Report: Deficiency Report
Function: Test, Adjust, & Balance
Date: 10/08/2025
Completed By: National TAB

PROJECT
10-06-25 QT #1121 EASLEY, SC

4855 CALHOUN MEMORIAL HWY

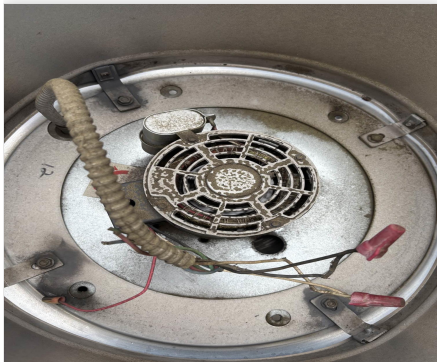
Issue Name : EF-1 not working
Description : When attempting to turn on the fan the motor began to smoke.
Created By : National TAB **Assigned To :** National TAB - Brianna Biggs
Status : Open
Priority : High **Asset Tag :** EF1
Originated Date : 10/08/2025 - Christian Moller - National TAB

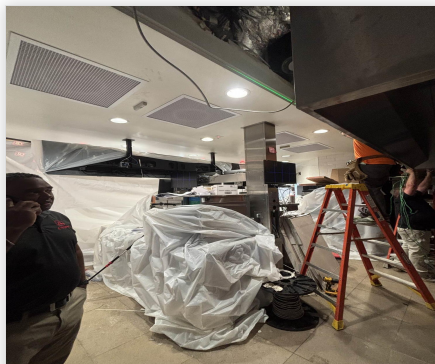
Issue Name : RTU 2 & 3 economizers don't work
Description : RTU 2&3 economizers do not work. When using the dial on the economizer itself as well as the Emerson board the flaps do not open.
Created By : National TAB **Assigned To :** National TAB - Brianna Biggs
Status : Open
Priority : High **Asset Tag :**
Originated Date : 10/08/2025 - Christian Moller - National TAB
